REMARKS

Appln. No. 09/701,338 Amdt. Dated Feb. 24, 2004 Reply to Office Action 11/24/03 Annotated Sheet

Fig. 2

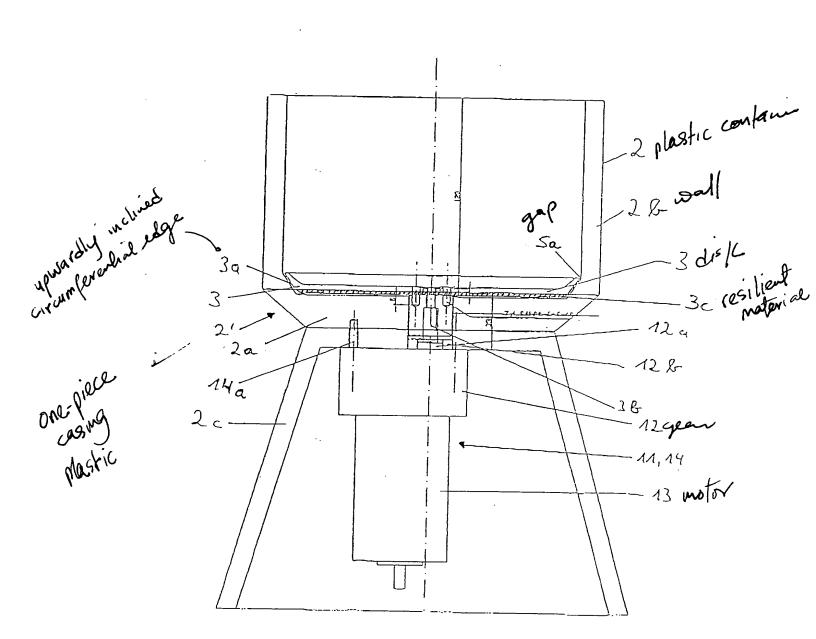
Applicant has also amended the fourth full paragraph on page 5 of the specification to include the disclosure originally provided at page 2, last full paragraph of the specification. Applicant has also amended claims 7 - 9 to correct the dependency thereof and has amended Figures 1 and 2 to correct the usage of reference numerals and show the resilient material on the underside of the disk, as required by the Examiner.
